**IN REPLY REFER TO:  
L-175-02-202**

**RE: 1964, S/N: 310I0145  
310I; N8145M  
DA: 07/04/02  
San Dimas, CA  
NTSB Report #: LAX02FA214**

MEB88-3

AUXILIARY FUEL PUMP WIRING MODIFICATION

Figure 1. Auxiliary Fuel Pump System Modification

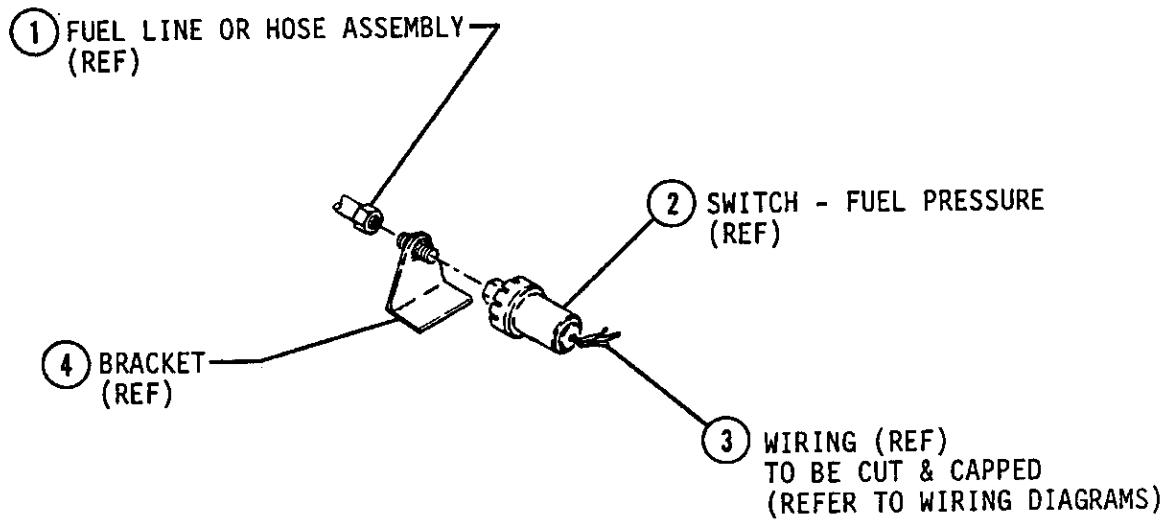
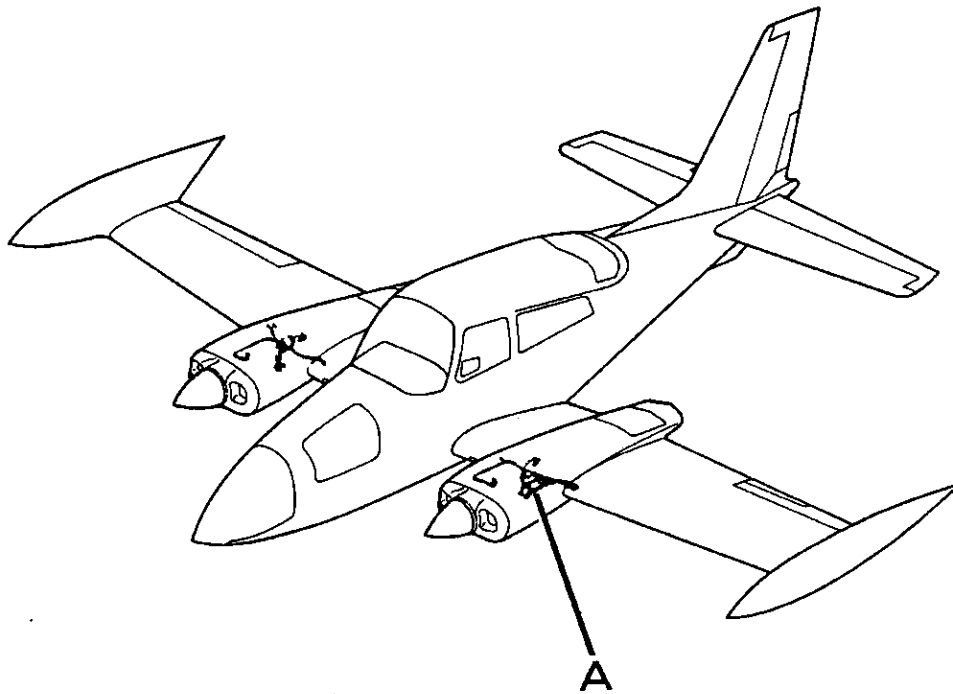
- A. Removal of fuel pressure switch and components (Refer to Detail A - Figure 1.).
1. Disconnect battery cable from aircraft and turn fuel selector switch OFF.

Figure 2. Auxiliary Fuel Pump Switches & Placards Installation - Sheet 3.

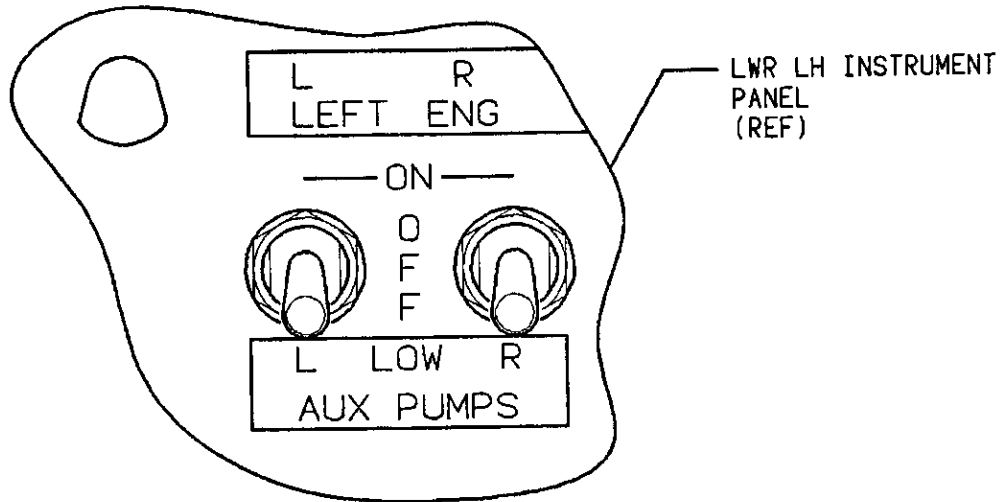
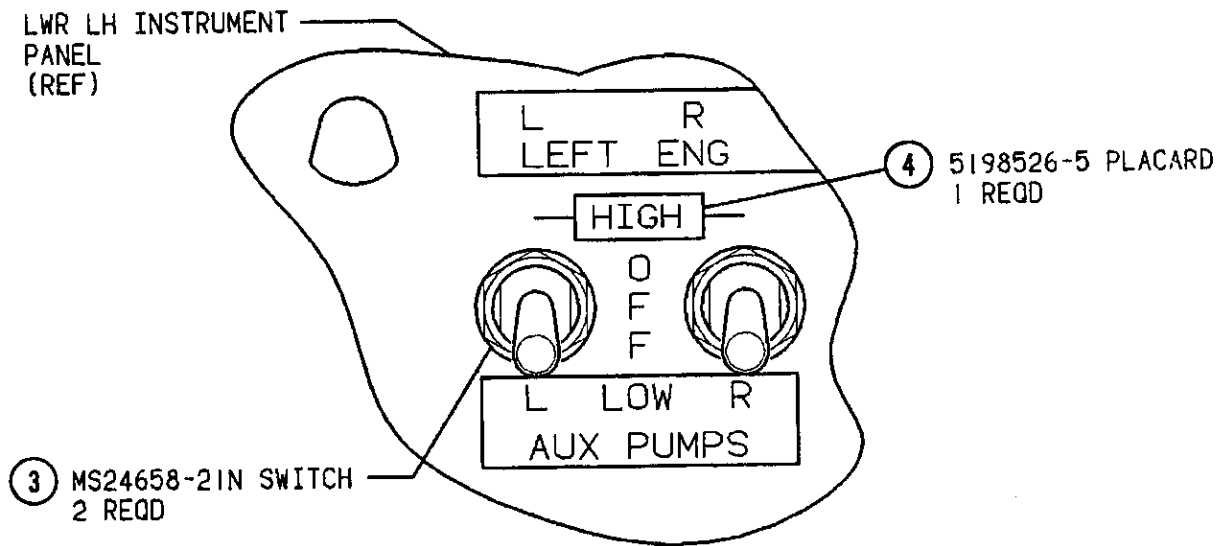
3. Install placards (2 & 4) on instrument panel over the silkscreen ON as shown in Figure 2, refer to appropriate figure sheet to match model and serial of aircraft.
- E. Modify existing wiring per appropriate wiring diagrams (refer to Figure 3 - Sheets 1 thru 5).
  1. This modification bypasses boost relay.
  2. Low boost circuit is unchanged.
  3. High boost is accomplished by:
    - (a) Jumper across boost relay (310).
    - (b) Adding wire from high switch terminal to primer switch.

Figure 3. Wiring Diagram - Sheet 3 of 8.

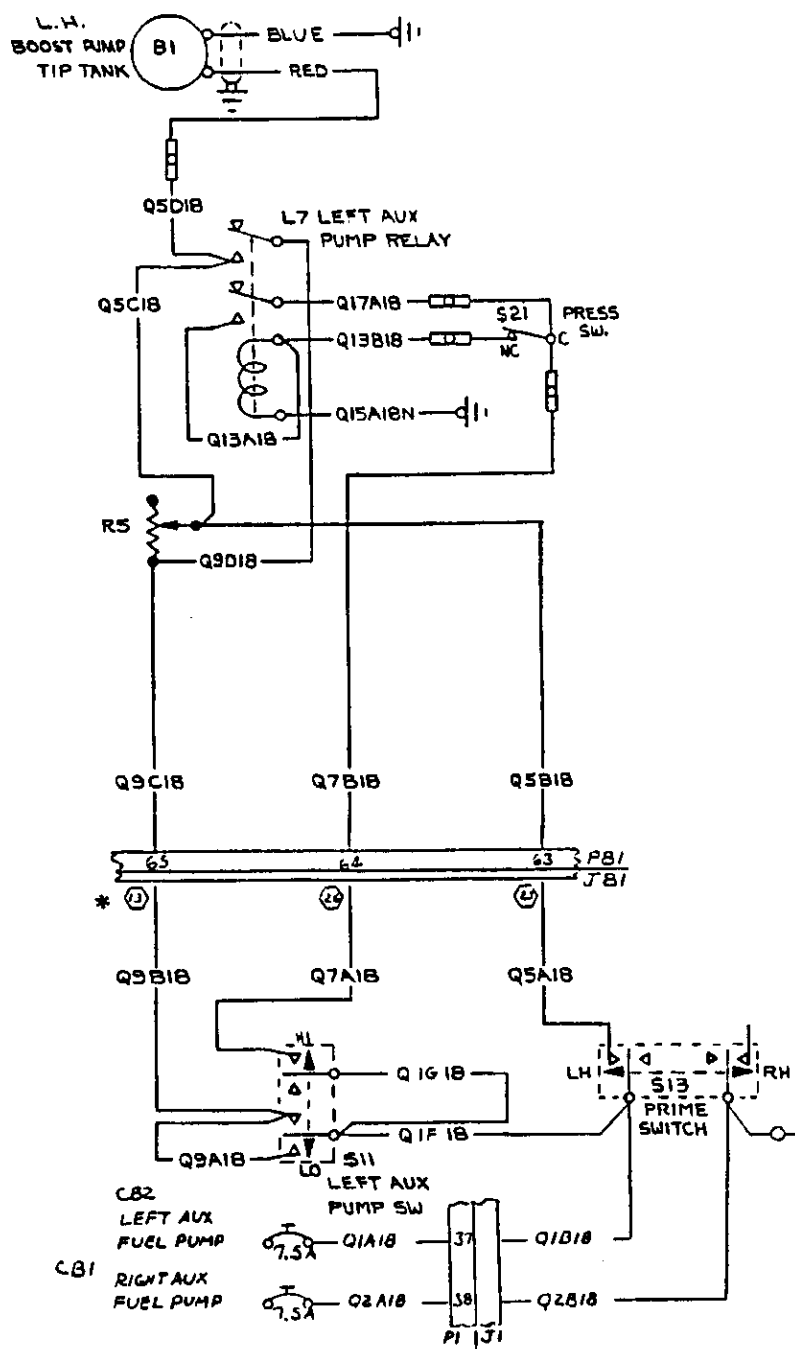
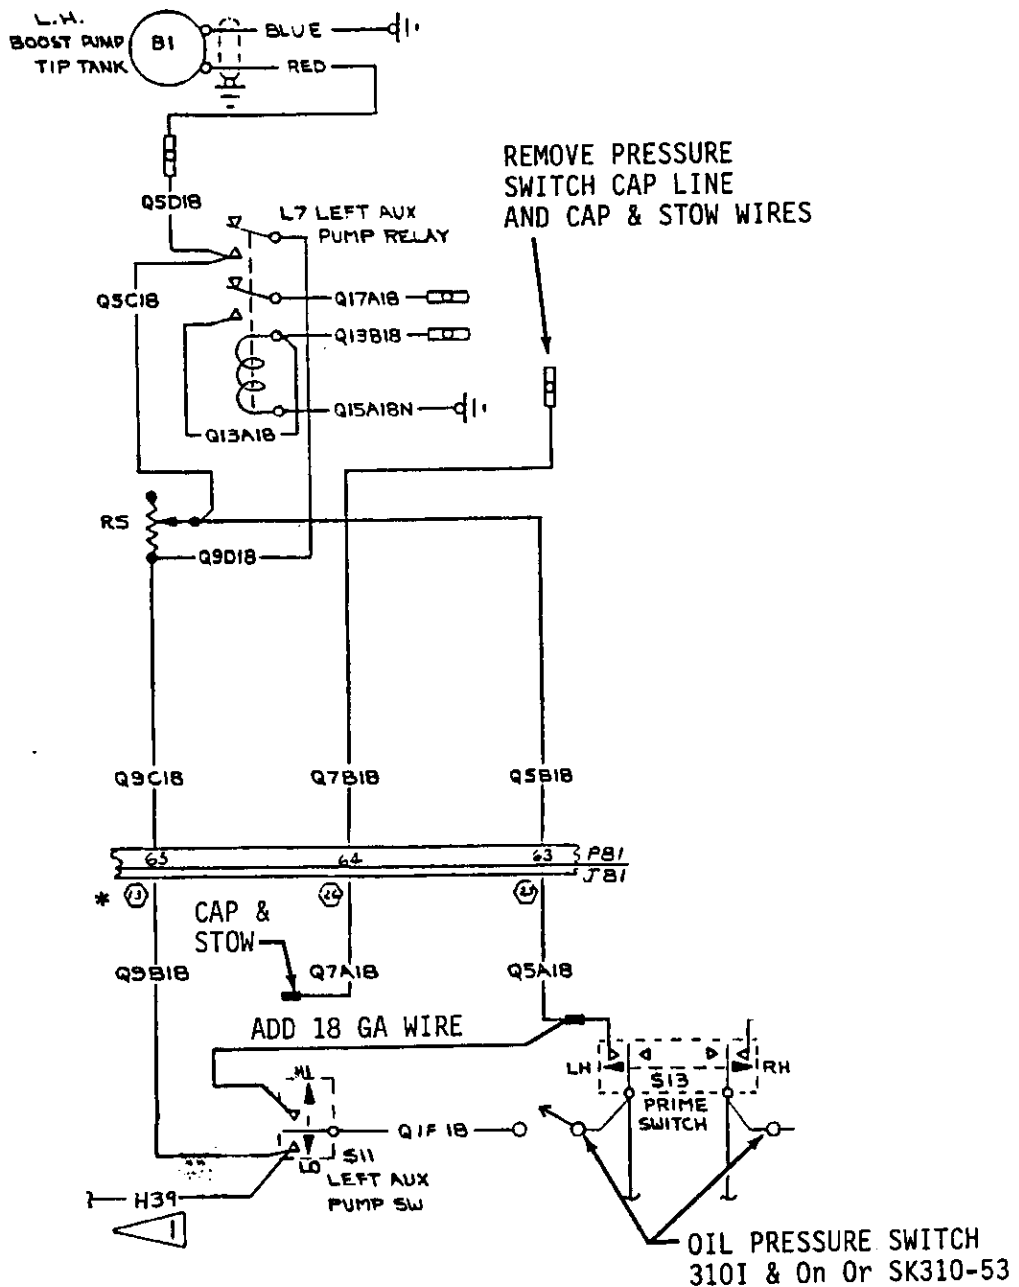
MODELS AFFECTED: 310I AND ON, 320B AND ON.

TO HEATER FUEL PUMP RELAY 310I AND 320B, RIGHT SIDE ONLY, RELAY OPERATES THROUGH R5 ON HI POSITION.

Figure 1. Auxiliary Fuel Pump System Modification - Sheet 1 of 2

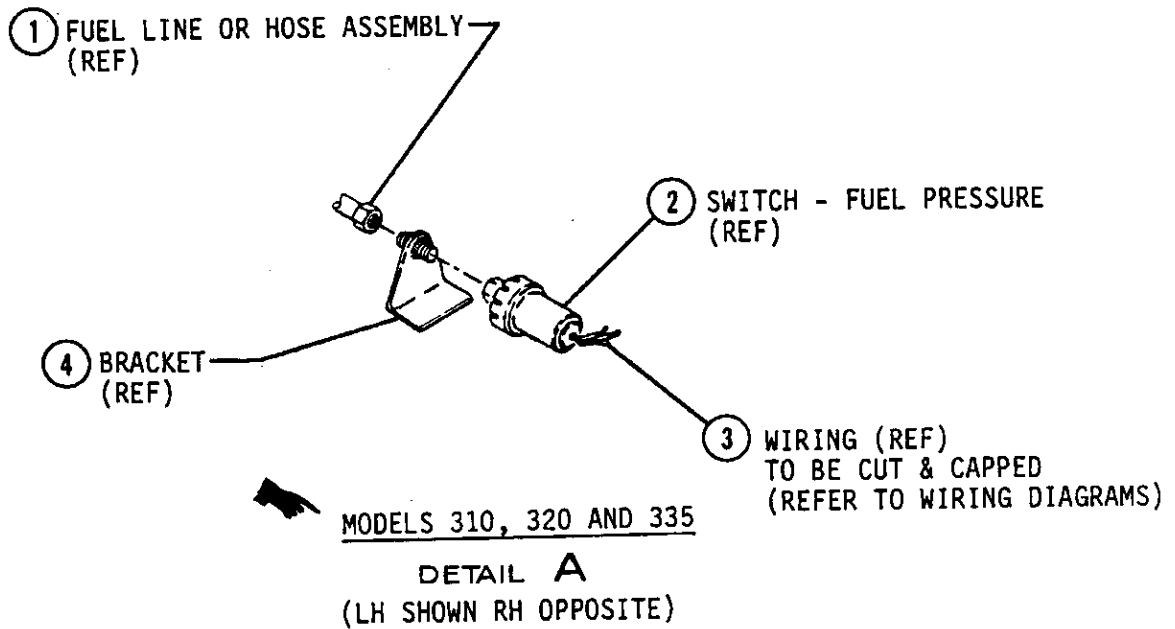
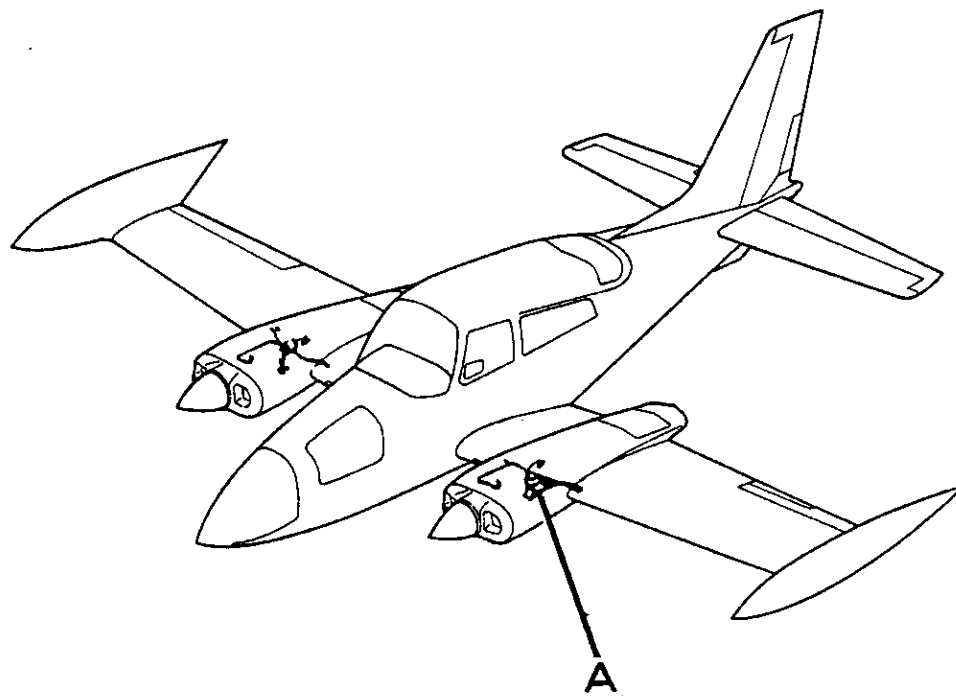
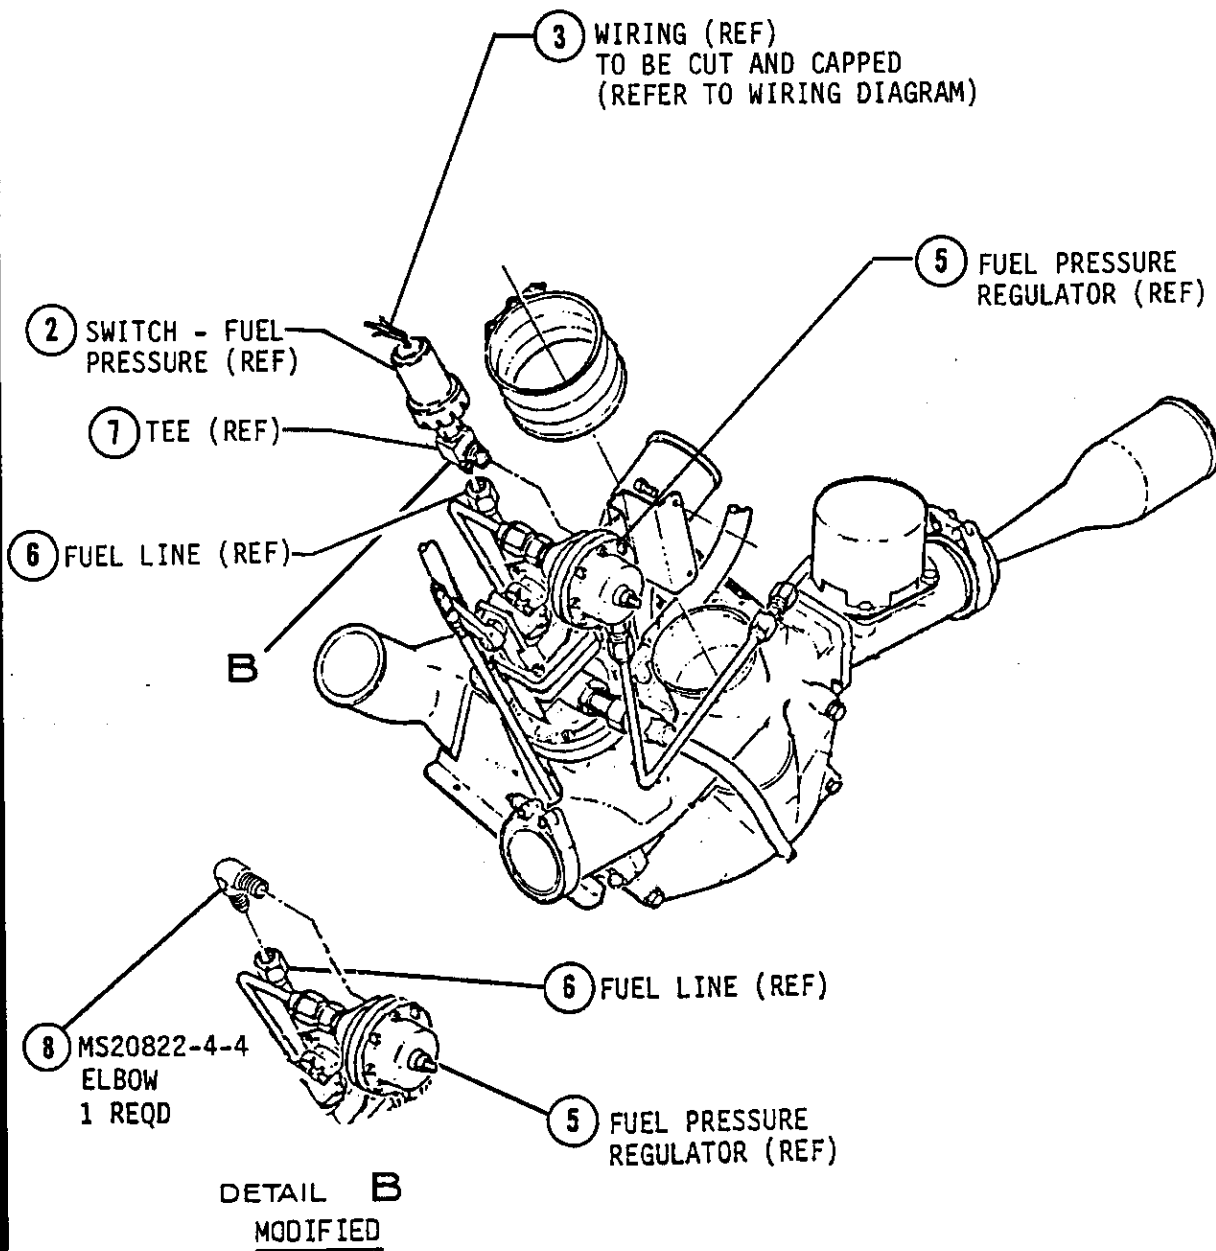
- A. Removal of fuel pressure switch and components, models 310, 320 and 335, (refer to Detail A - Figure 1).
1. Disconnect battery cable from airplane and turn fuel selector switch OFF.

7. Repeat the procedure for the opposite engine.
- B. Removal of fuel pressure switch and components, model 340 (refer to Detail A - Figure 1 - Sheet 2).

7. Install MS20822-4-4 Elbow (8) in fuel pressure regulator (5) and connect fuel line (6) to elbow (8), (refer to Detail B-Figure 1-Sheet 2).
  8. Repeat the procedure for the opposite engine.
- C. Removal of the existing RH and LH auxiliary fuel pump switches (refer to Figure 2 - Sheets 1 thru 7).
1. Remove Pilot's seat from airplane.
  2. Remove existing auxiliary fuel pump switches in location (3) from the lower LH instrument panel.
  3. Remove wires from switches and discard switches.

Figure 2. Auxiliary Fuel Pump Switches & Placards Installation - Sheet 3

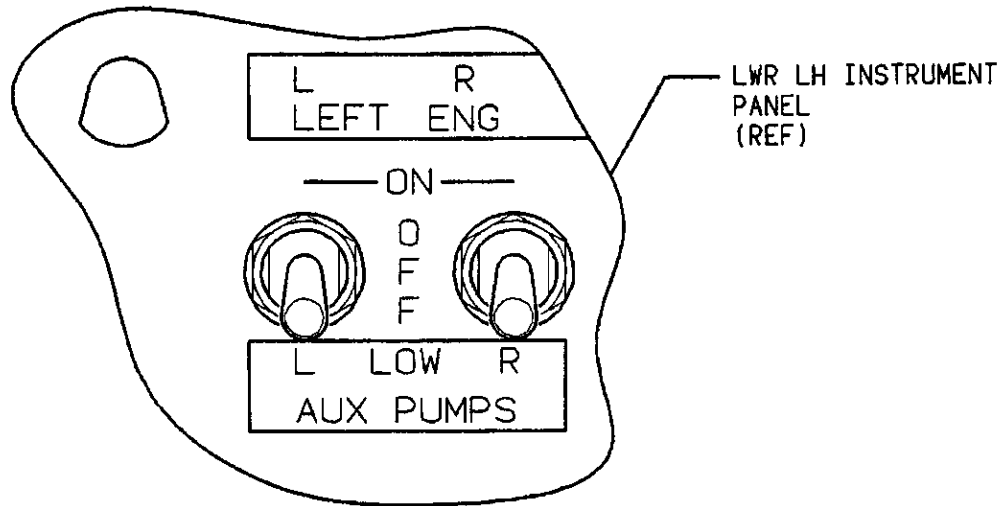
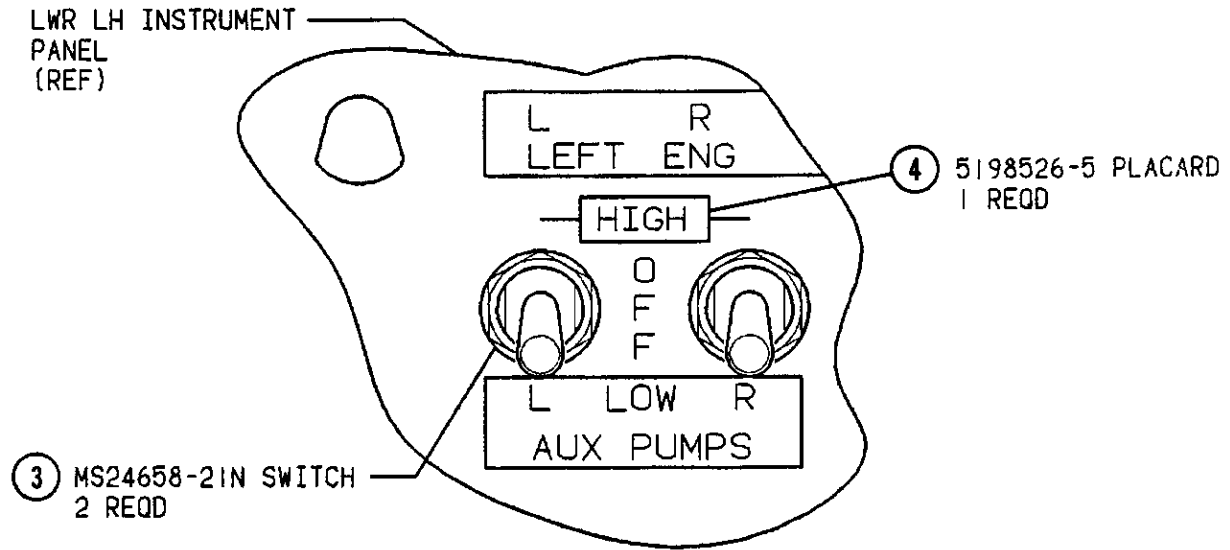
3. Install placards (2 and 4) on instrument panel over the silkscreen ON as shown in Figure 2, refer to appropriate figure sheet to match model and serial of aircraft.
